Access Compliance Report

Public Rights-of-Way

Intersection ID: 12365	Main Street: E_10TH_ST	Cross Street: N_ALEXANDER_ST	Location: N
ADA ID: C738D0489F06	Ramp Type: PerpDiag	Initial Pass/Fail: Fail	Overall Compliance: No
Severity Score: 13.75			
Codes/Mitigation Info/Possible Solution		Field Measurements/Component Compliance

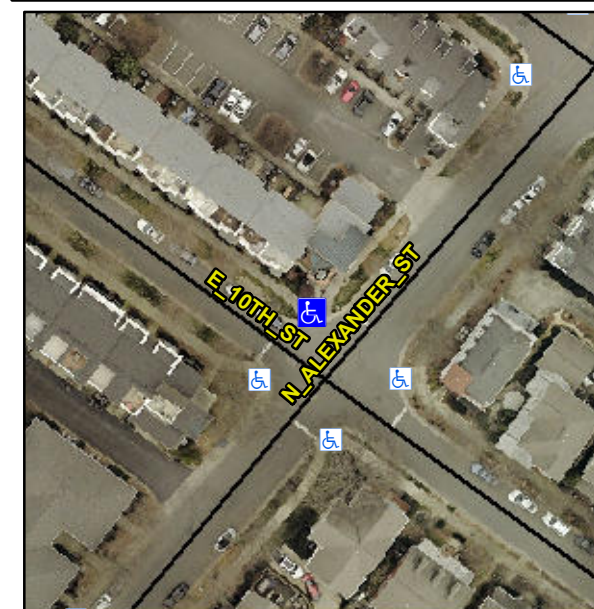
Not Found, R304.2.2, R304.5.3

Compliance	Description	Data	Compliance	Description	Data
N/A	Ramp Length (in)	86.0	No	Ramp Slope (%)	10.1
Yes	Ramp Width (in)	49.0	No	Ramp XSlope (%)	3.8
N/A	Flare Type LT	N/A	N/A	Flare Type RT	N/A
N/A	Flare Slope LT (%)	N/A	N/A	Flare Slope RT (%)	N/A
N/A	Flare Traversable LT?	N/A	N/A	Flare Traversable RT?	N/A
N/A	Landing Length (in)	N/A	N/A	DWS Provided?	N/A
N/A	Landing Width (in)	N/A	N/A	DWS Contrast?	N/A
N/A	Landing Slope (%)	N/A	N/A	DWS Length (in)	N/A
N/A	Landing X Slope (%)	N/A	N/A	DWS Full Width?	N/A
N/A	Landing Curb? (Y/N)	N/A	N/A	DWS Offset (in)	N/A
N/A	Shared Landing?	N/A			
N/A	Gutter Ponding?	N/A	N/A	Gutter Slope (%)	N/A
N/A	Gutter Lip Ht (in)	N/A	N/A	Gutter X Slope (%)	N/A
N/A	Painted X Walk1?	No	N/A	Painted X Walk2?	No
	X Walk 1 Direction	To SW		X Walk 2 Direction	To SE
N/A	X Walk 1 Width (in)	N/A	N/A	X Walk 2 Width (in)	N/A
	X Walk 1 Slope (%)	2.1		X Walk 2 Slope (%)	6.1
	X Walk 1 X Slope (%)	6.6		X Walk 2 X Slope (%)	0.2

Remove & Replace Curb Ramp With Two New Directional Ramps or Equivalent.
